SEWAGE DISPOSAL SYSTEM

HOWARD COUNTY HEALTH DEPARTMENT

SUBDIVISION West Friendship Estates LOT 29

RE: 3148 River Valley Chase, *West Friendship Estates, Lot 29*

BP 64366
LOT 29

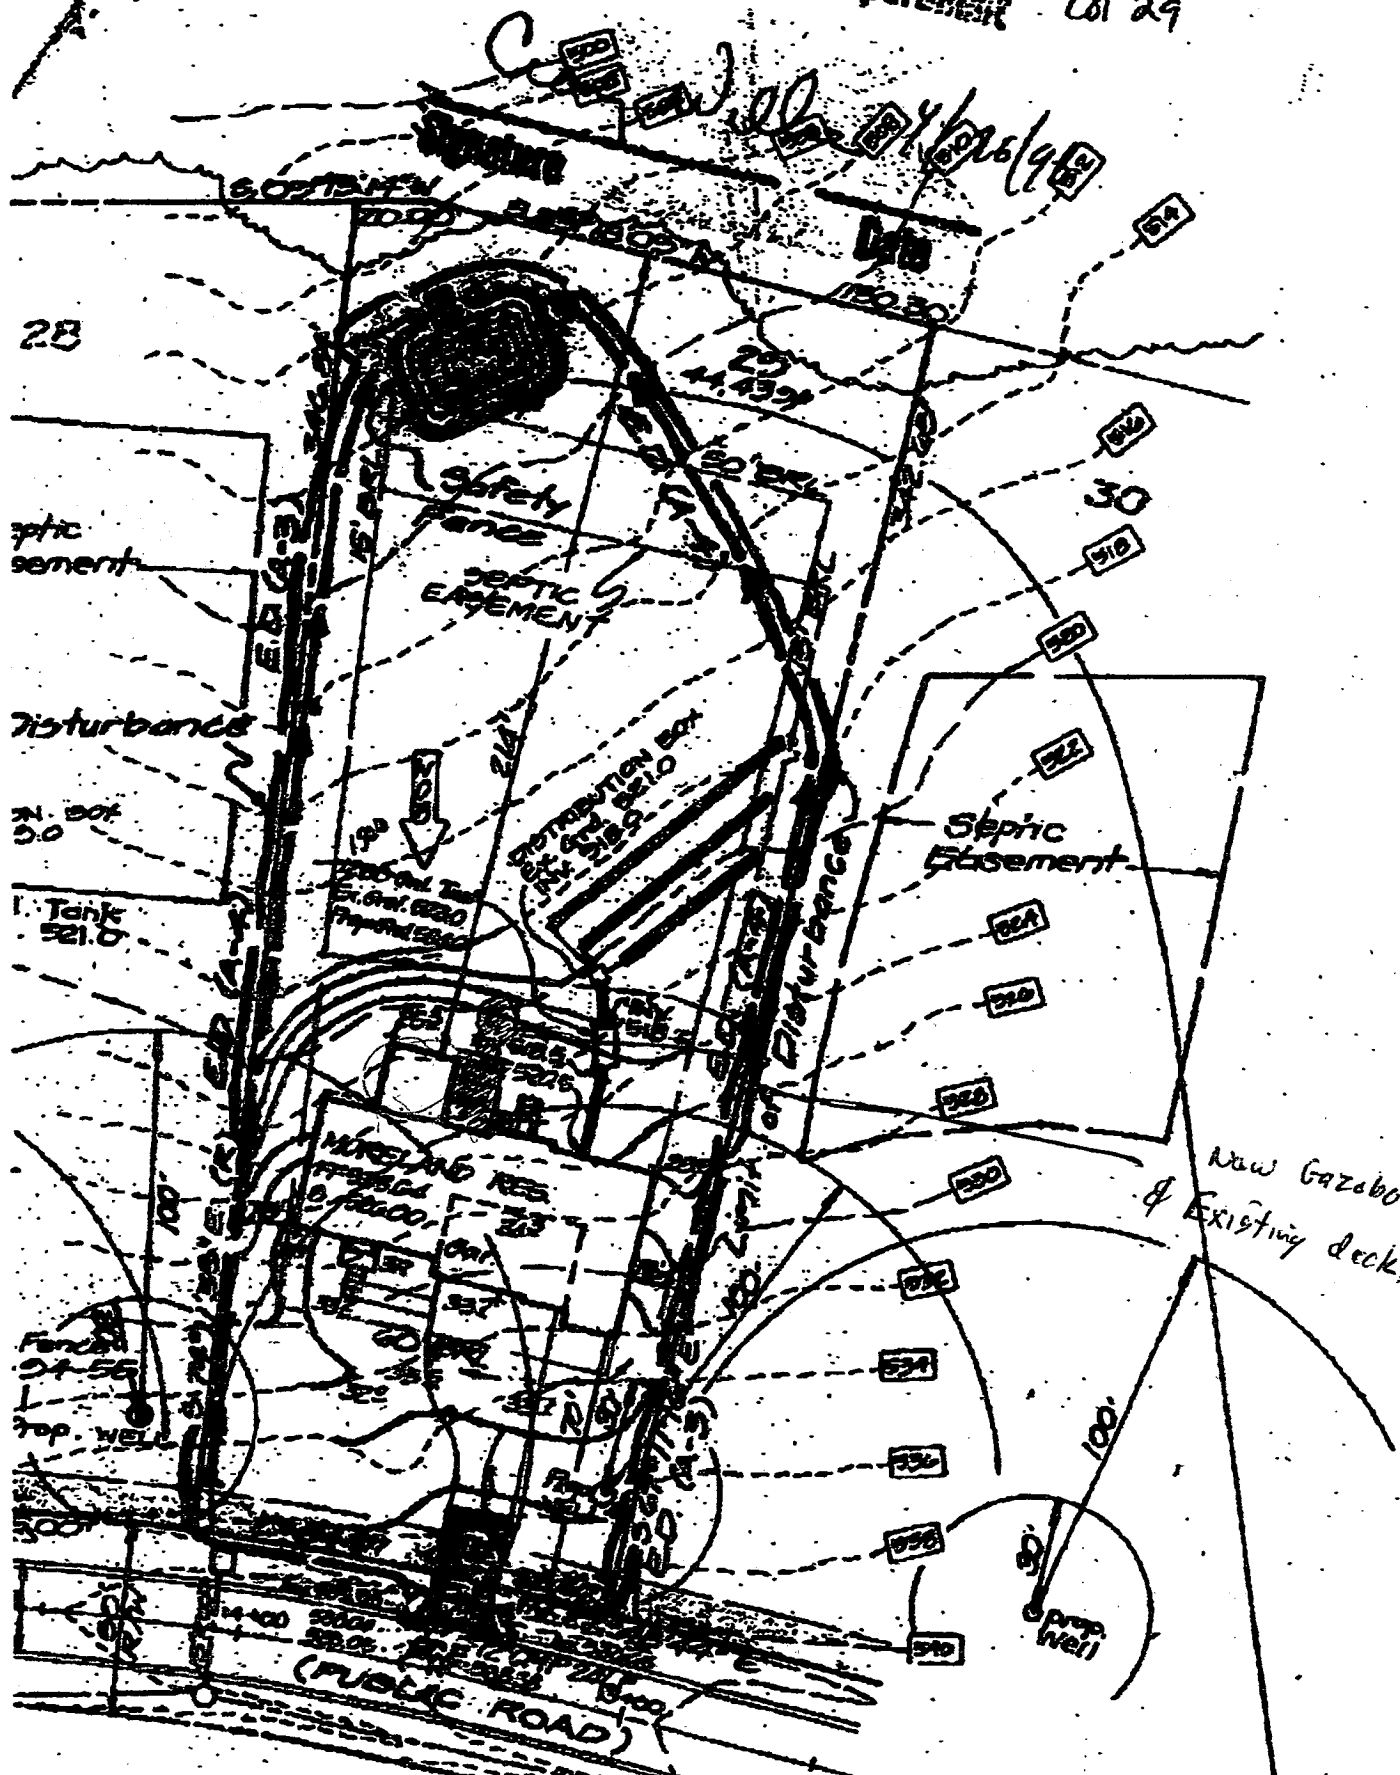
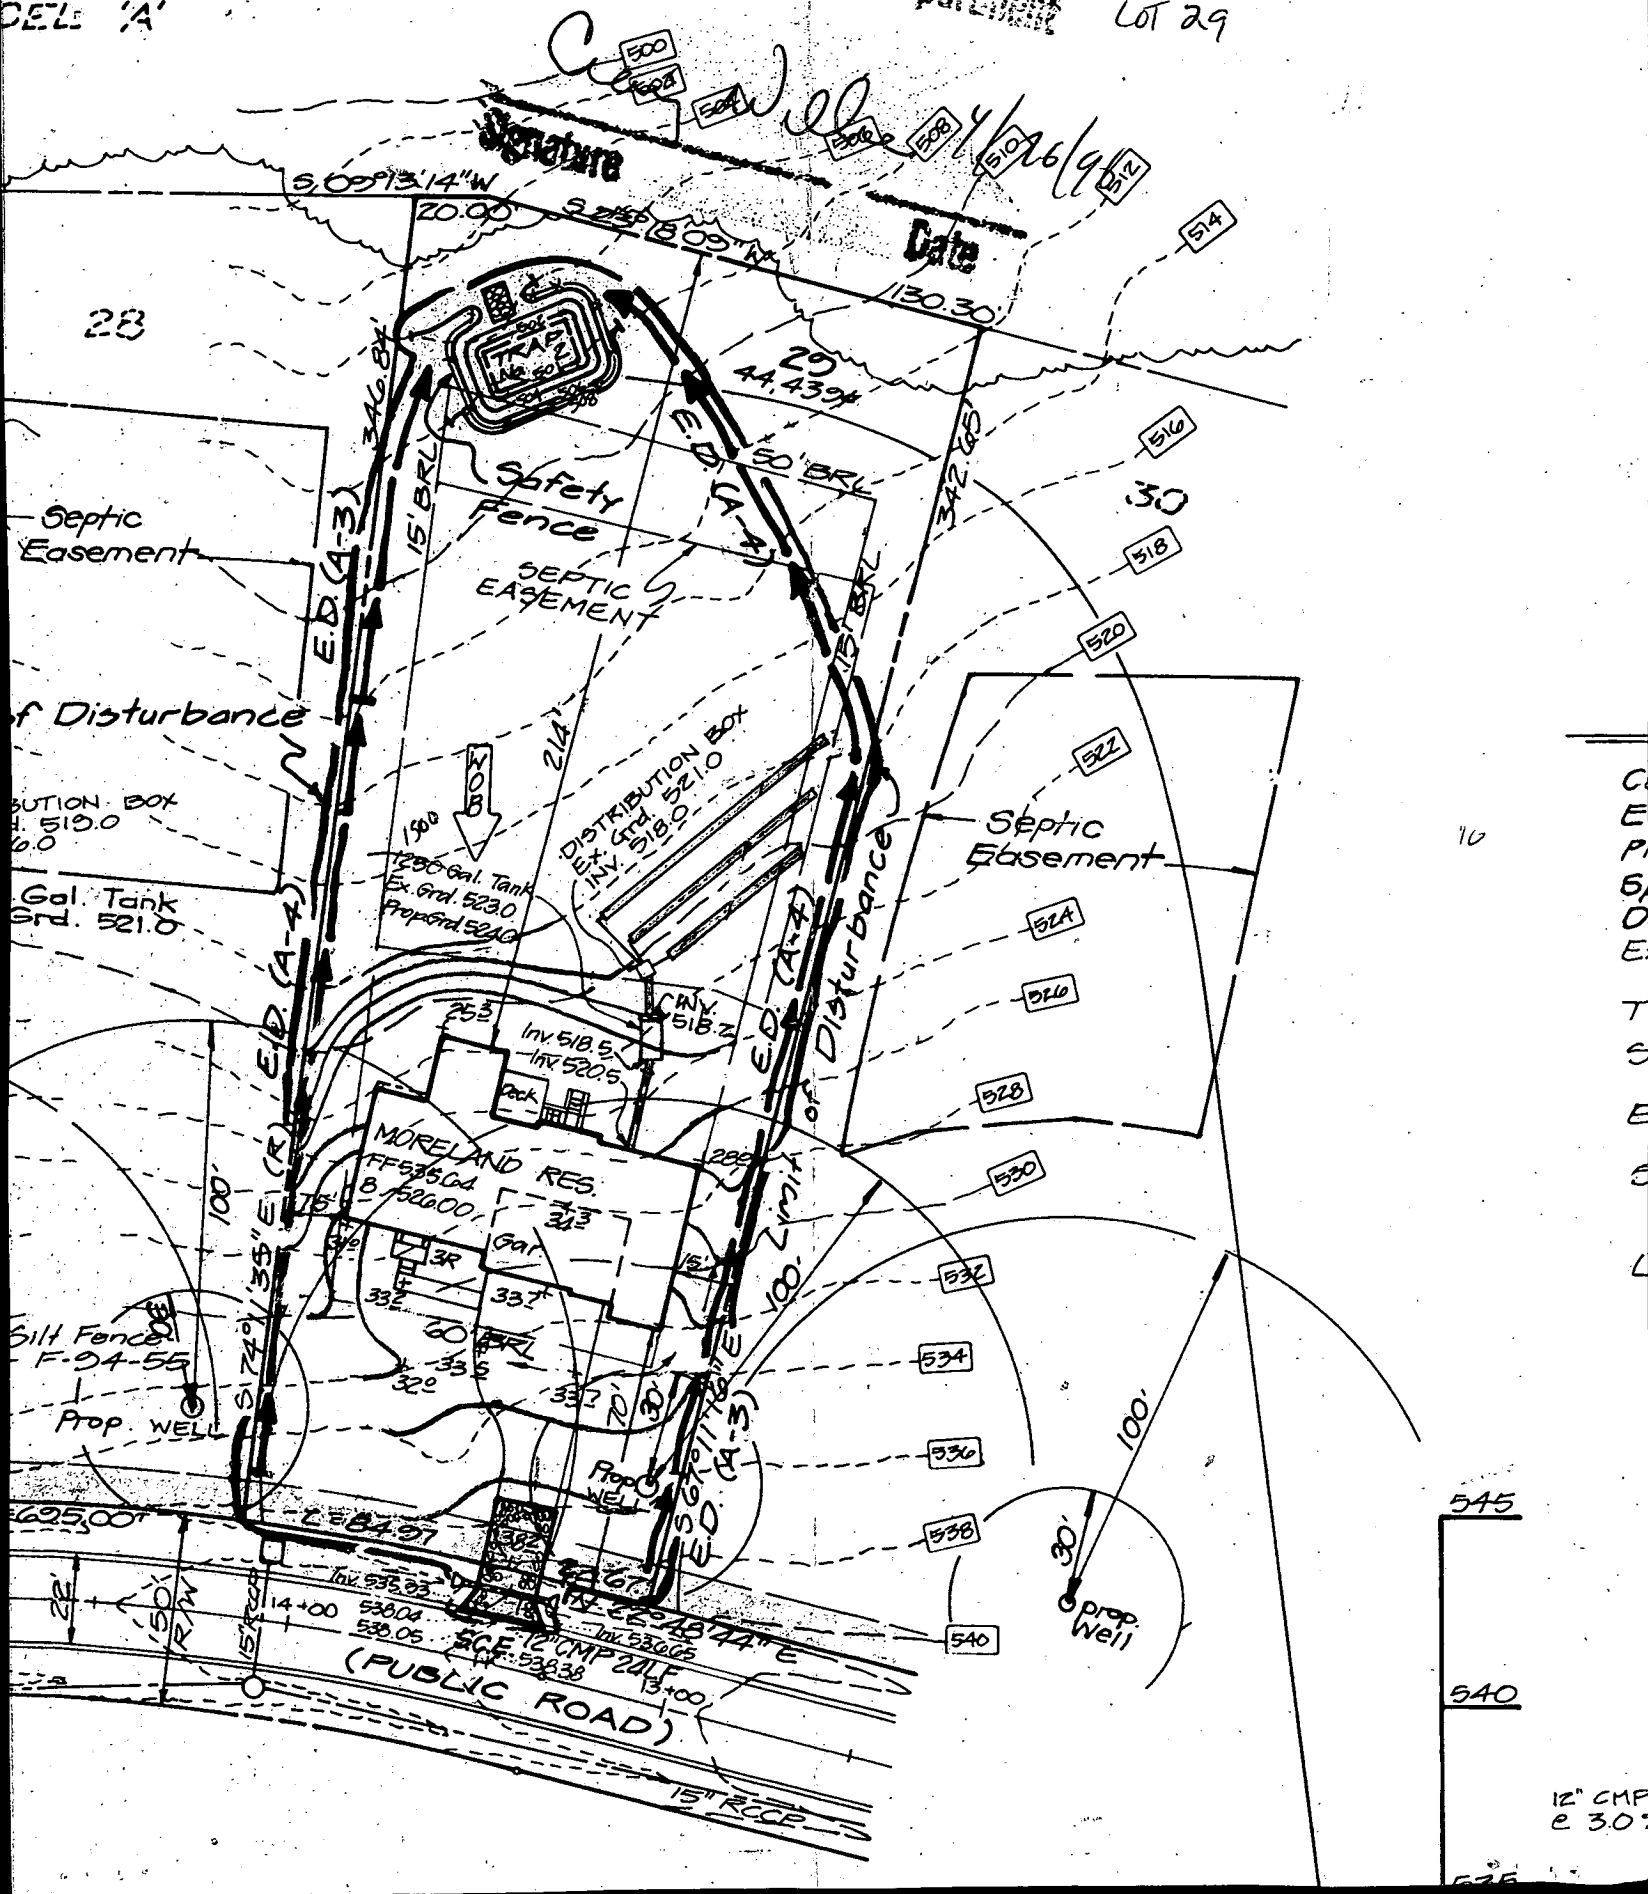
We have received a variance requesting the required 10' setback to post and pier footings to the sewage disposal easement at the above referenced property be waived to 4'. In accordance with agency standards, an acceptable setback distance is no less than 5'. Therefore, your request is **denied**. A revised scaled drawing showing an acceptable setback distance can be used to rescind this denial.

WALKWAY TO GAZEBO
BUILDING PERMIT
RP# 60012366
APR 24 4 23 03
DATE 4/23/03
DESC. OF WORK: walkway to gazebo

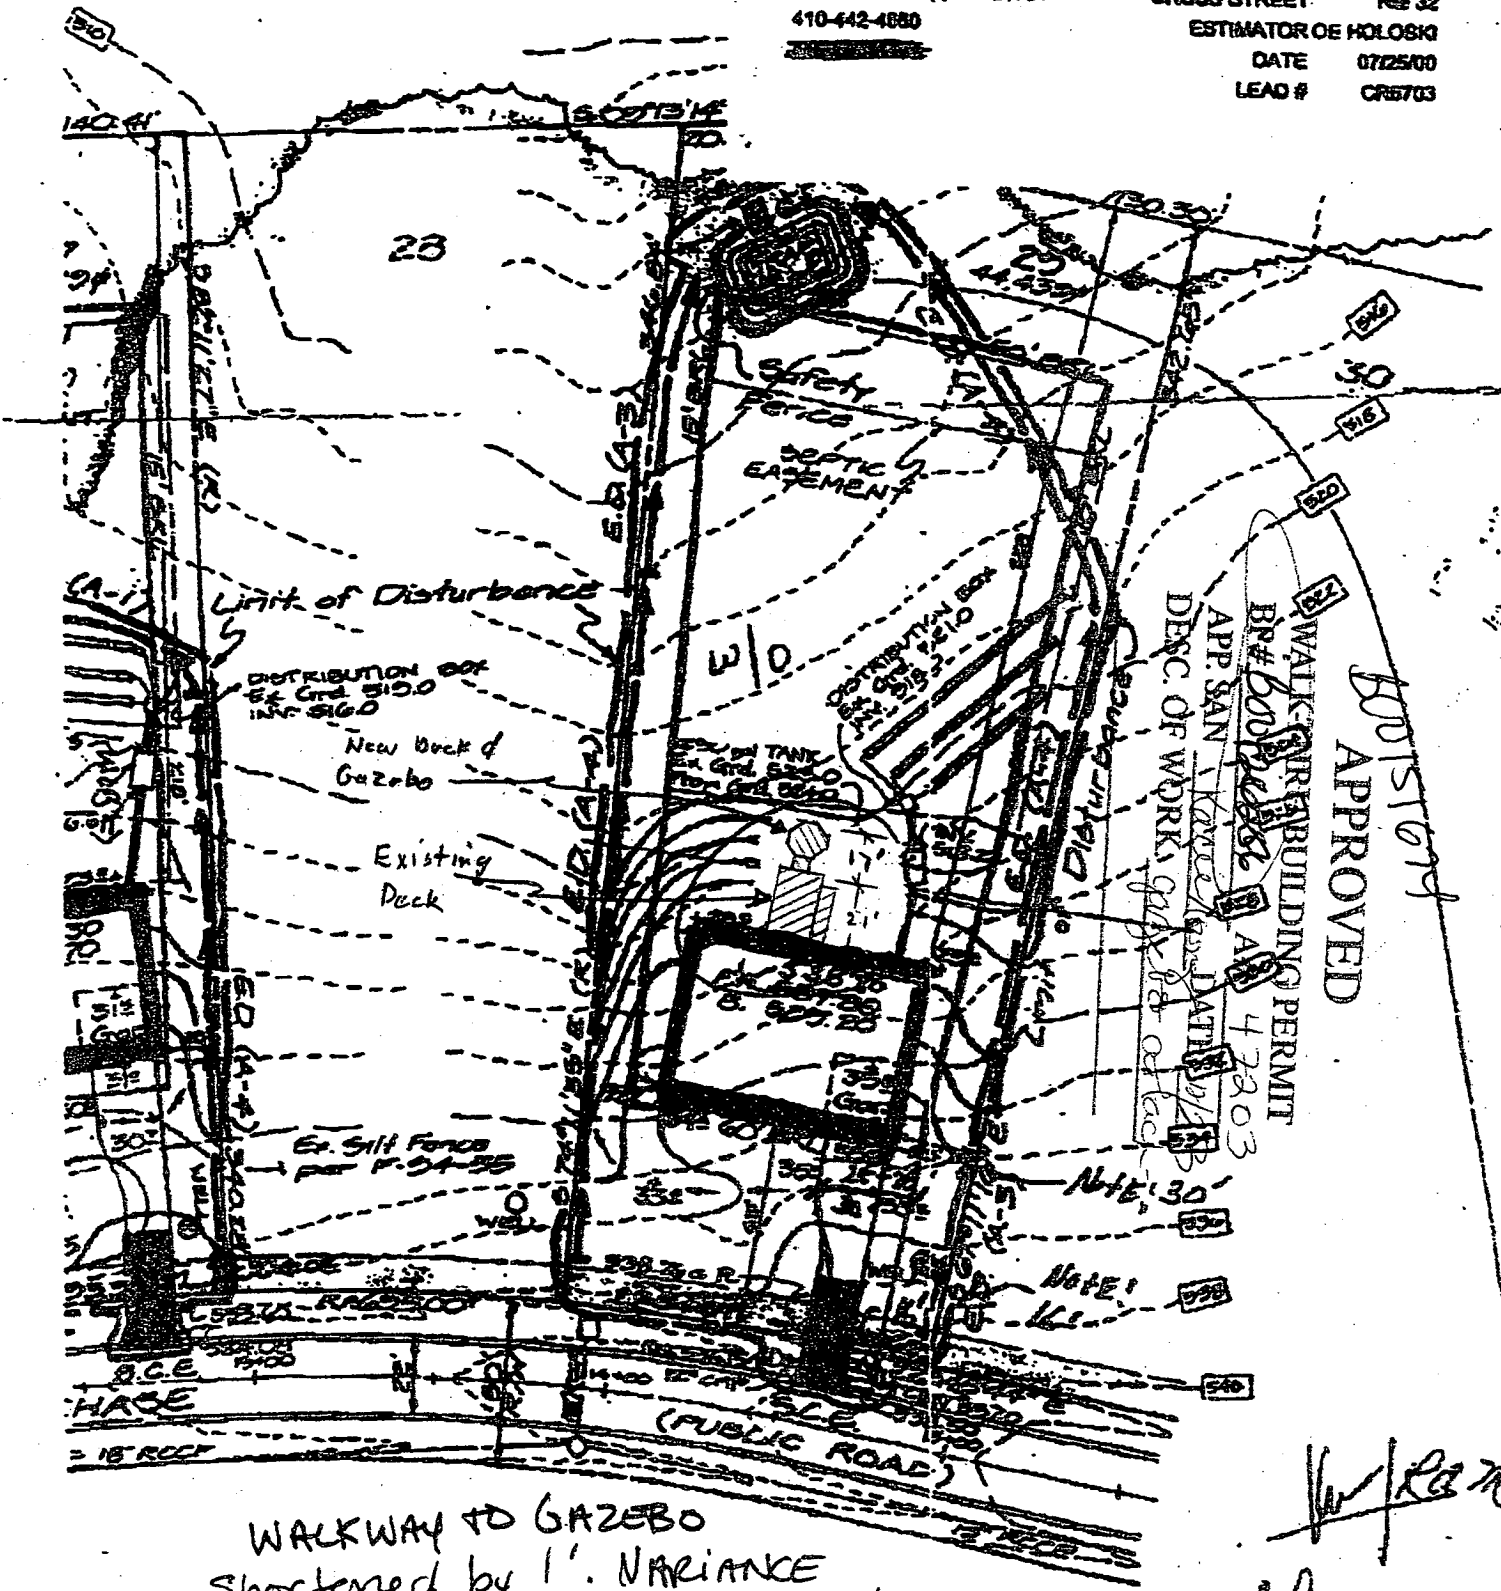
I am requesting a variance to the ten foot setback requirement from our septic easement for the construction of a gazebo on our property. Note on the attached drawings that two 12" footings are 4' feet and two 14" inch footings are 7' 11" from the easement. The gazebo is over 8' above grade. Should our current septic system fail or require service none of these footings or their associated posts should pose a problem for equipment or for the relocation of the drain field trenches.

We have received a variance requesting the required 10' setback to post and pier footings to the sewage disposal easement at the above referenced property be waived to 4'. In accordance with agency standards, an acceptable setback distance is no less than 5'. Therefore, your request is **denied**. A revised scaled drawing showing an acceptable setback distance can be used to rescind this denial.

WALKWAY TO GAZEBO
Shortened by 1'. VARIANCE
response by JB on 12-14-04 OK'd 5' SETBACK
